Access Compliance Report

Public Rights-of-Way

(Curb Ramps)

Intersection ID: 52476	Main Street: WHITEHALL_EXECUTIVE_CENTER_DR	Cross Street: N/A	Location: NE
ADA ID: 09476B937BB0	Ramp Type: Perp	Initial Pass/Fail: Fail	Overall Compliance: No
Codes/Mitigation Info/Possible Solution		Field Measurements/Component Compliance	
Severity Score: 13.75

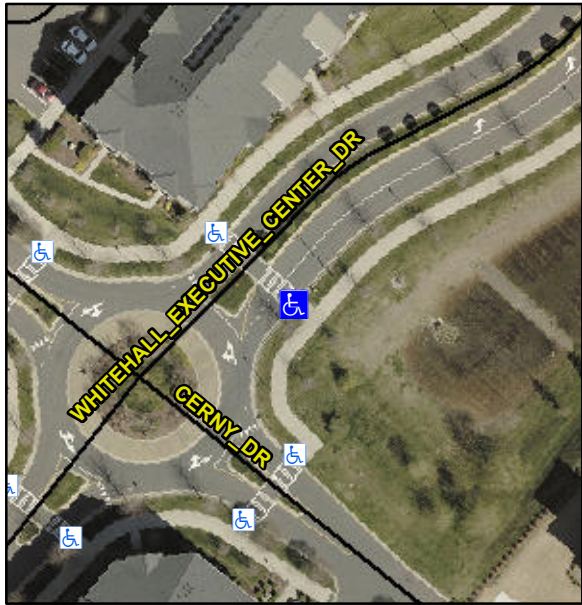
Not Found, R304.2.2, R304.5.3

Compliance	Description	Data	Compliance	Description	Data
N/A	Ramp Length (in)	93.0	No	Ramp Slope (%)	9.6
Yes	Ramp Width (in)	94.0	No	Ramp XSlope (%)	4.5
N/A	Flare Type LT	N/A	N/A	Flare Type RT	N/A
N/A	Flare Slope LT (%)	N/A	N/A	Flare Slope RT (%)	N/A
N/A	Flare Traversable LT?	N/A	N/A	Flare Traversable RT?	N/A
N/A	Landing Length (in)	N/A	N/A	DWS Provided?	N/A
N/A	Landing Width (in)	N/A	N/A	DWS Contrast?	N/A
N/A	Landing Slope (%)	N/A	N/A	DWS Length (in)	N/A
N/A	Landing X Slope (%)	N/A	N/A	DWS Full Width?	N/A
N/A	Landing Curb? (Y/N)	N/A	N/A	DWS Offset (in)	N/A
N/A	Shared Landing?	N/A			
N/A	Gutter Ponding?	N/A	N/A	Gutter Slope (%)	N/A
N/A	Gutter Lip Ht (in)	N/A	N/A	Gutter X Slope (%)	N/A
N/A	Painted X Walk1?	Yes	N/A	Painted X Walk2?	N/A
	X Walk 1 Direction	To NW		X Walk 2 Direction	N/A
N/A	X Walk 1 Width (in)	113.0	N/A	X Walk 2 Width (in)	N/A
	X Walk 1 Slope (%)	3.3		X Walk 2 Slope (%)	N/A
	X Walk 1 X Slope (%)	3.2		X Walk 2 X Slope (%)	N/A

Remove & Replace Entire Ramp.
